UPPER TENMILE CREEK

Operable Unit Number Two Rimini Superfund Site

Value Engineering Study For U.S. Environmental Protection Agency Region Eight, Montana State Office

Final Report

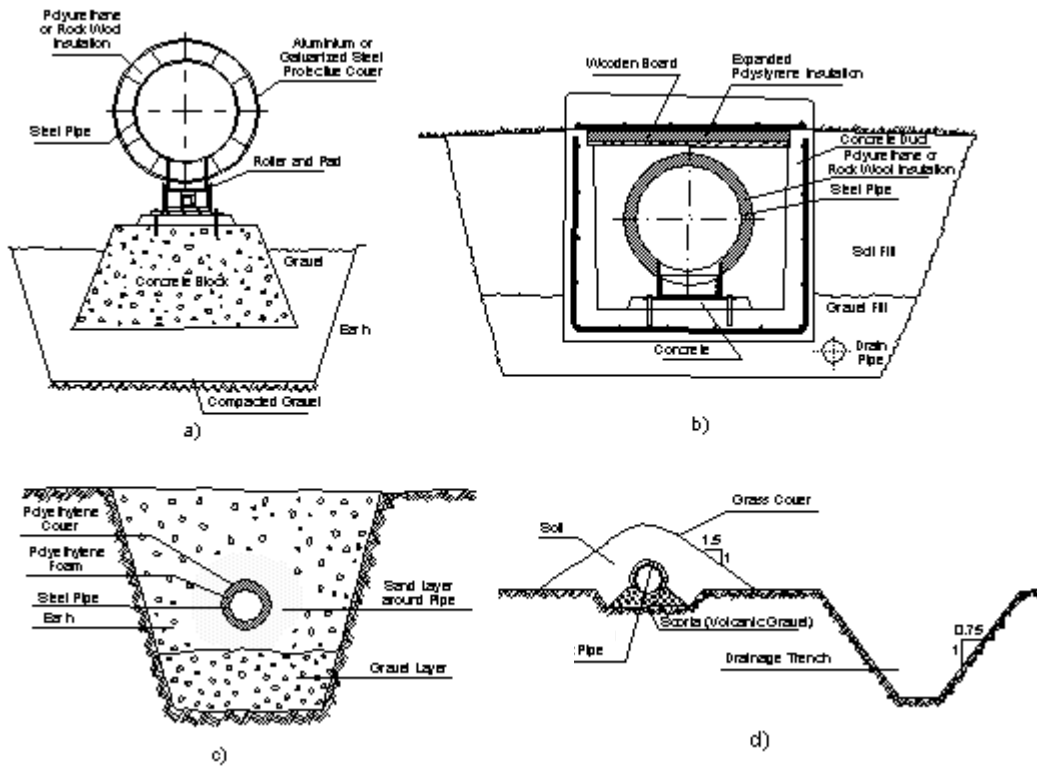
Use an insulated pipe to allow for shallower excavation depths in rocky areas and to facilitate mounding over the pipeline to provide necessary cover where bedrock is competent and would require blasting. In areas where piping may be exposed additional protection can be attained through the use of heat trace tape within an insulation layer or within the actual pipe.

- Reduces the volume of competent rock that would require blasting and reduces the associated worker risk.
- Facilitate the use of built up cover to reduce rock excavation and/or blasting and minimize trench excavation.
- Heat trace or insulation may be used on less than the entire pipe run depending on the outcome of heat loss calculations.

- Appropriate insulation system may not be readily available and may require a long lead time.
- Insulated pipe is much more costly to install than un-insulated pipe.
- Availability of specialty pre insulated piping may require long distance shipping with associated costs.
- Suppliers will be hesitant to warrantee a product.
- The new Sewer and Water District will be hesitant to accept a system without warranty.
